Re: Subdivision Review Application for Final United Village Development Plat by
Snelling-Midway Redevelopment

LOUCKS COMMENTS TO THE PRELIMINARY PLAT CONDITIONS TO BE INCORPORATED INTO THE FINAL PLAT (Red Text)

Approving the Preliminary Plat for United Village Development.

COMMENT #6

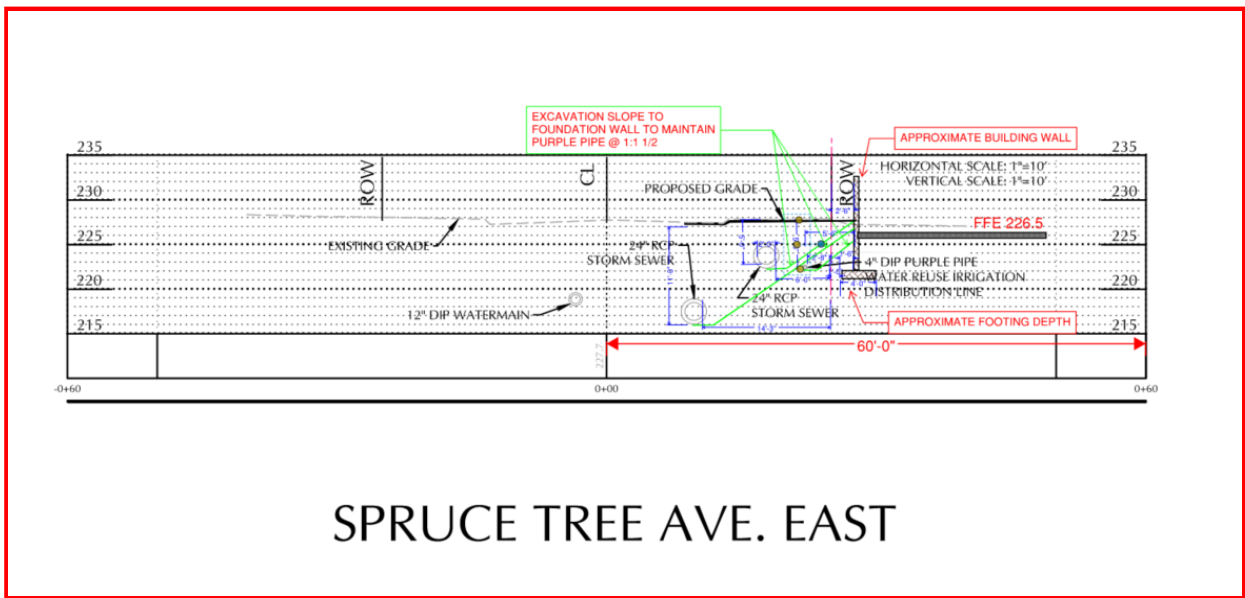
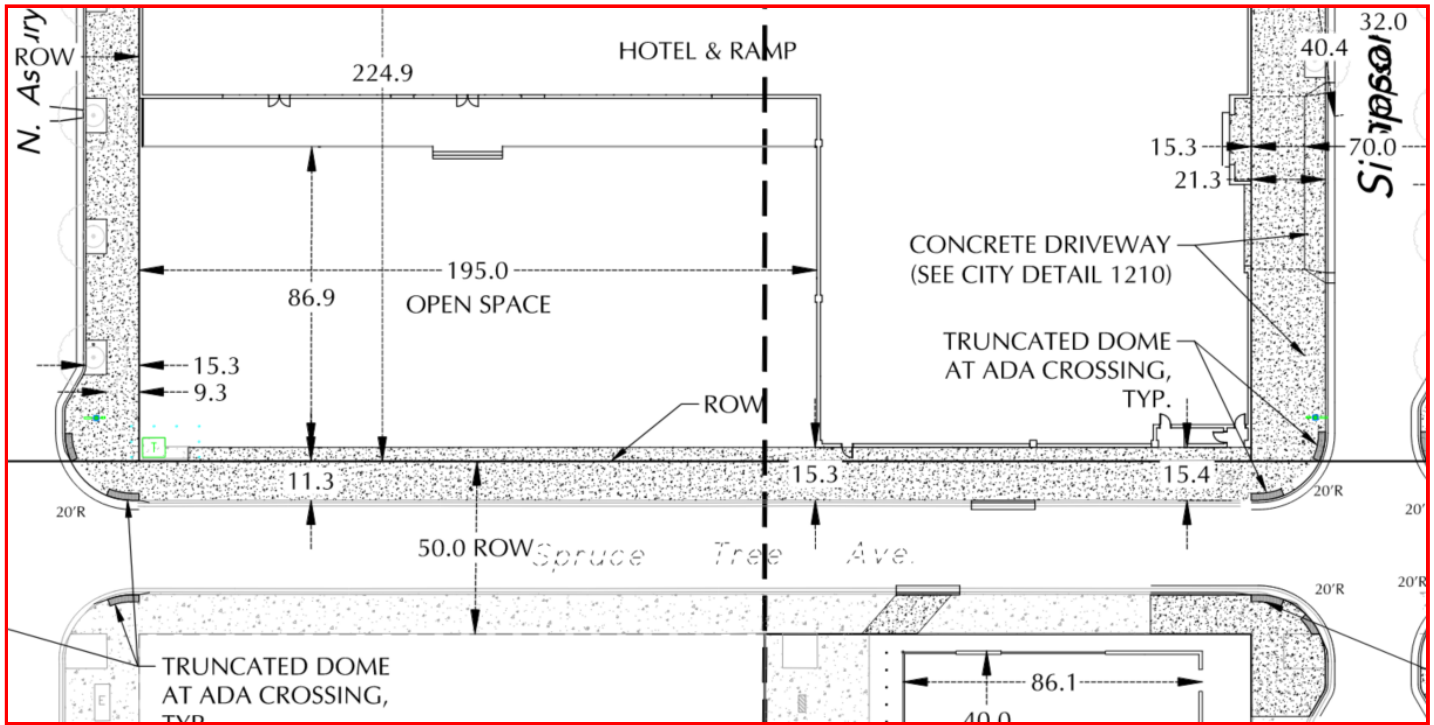
6. The applicant shall grant to the City easements, the details of which are to be determined by the Department of Public Works, to ensure sufficient area is provided for transportation and utility needs. It is anticipated that easements will be needed north of the proposed north right-of-way line for Spruce Tree Avenue, south of the proposed south right-of-way line for Spruce Tree Avenue, and at the quadrants of the Asbury Street/Spruce Tree Avenue and Simpson Street/Spruce Tree Avenue intersections. The easements shall be filed with the office of the county recorder of Ramsey County after the final plat is recorded, but no later than December 31, 2023. **The 60% Construction Plan submittal does not anticipate any additional utilities to be installed in this area of Spruce Tree. See attached typical cross-section of existing utilities. A width TO BE DETERMINED for Pedestrian and Drainage & Utility Easement are shown on the final plat north and south of Spruce Tree.**

Final plat must provide sufficient right-of-way, easements, or lease area to provide ADA compliant public sidewalks and pedestrian crossings, street trees, streetlights, bike lanes and other potential improvements in the public roadway right-of-way within the plat area. A width TO BE DETERMINED for Pedestrian and Drainage & Utility Easement are shown on the final plat north and south of Spruce Tree.

Final plat must provide sufficient right-of-way for ADA compliant pedestrian access routes and landing zones at intersections as well as truck turning movements for the design vehicle and for turning movements for emergency vehicle access. The 60% Construction Plan submittal shows how the public sidewalks can be accomplished within the existing 50 foot ROW using the designated truck turning movements. A width TO BE DETERMINED for Pedestrian and Drainage & Utility Easement are shown on the final plat north and south of Spruce Tree.
